Recall Information Bulletin

No: C10114 **Issued:** 12/16/2020

Re: Exhaust Studs

Safety Recall C10114 – Exhaust Studs

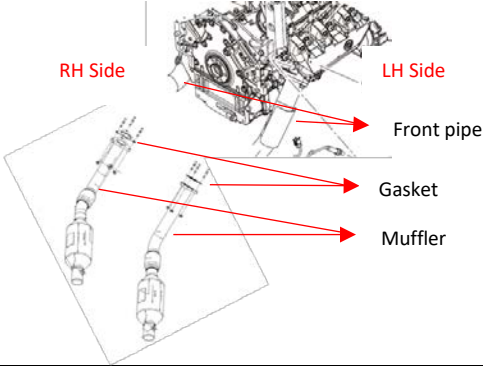
The exhaust studs will be tightened to the proper torque specification, the exhaust flange gaskets will be replaced along with any damaged studs or nuts.

2. Tighten the exhaust studs using instructions found in the Modification Procedure on the next page.
3. After reassembly, confirm that there are no leaks.
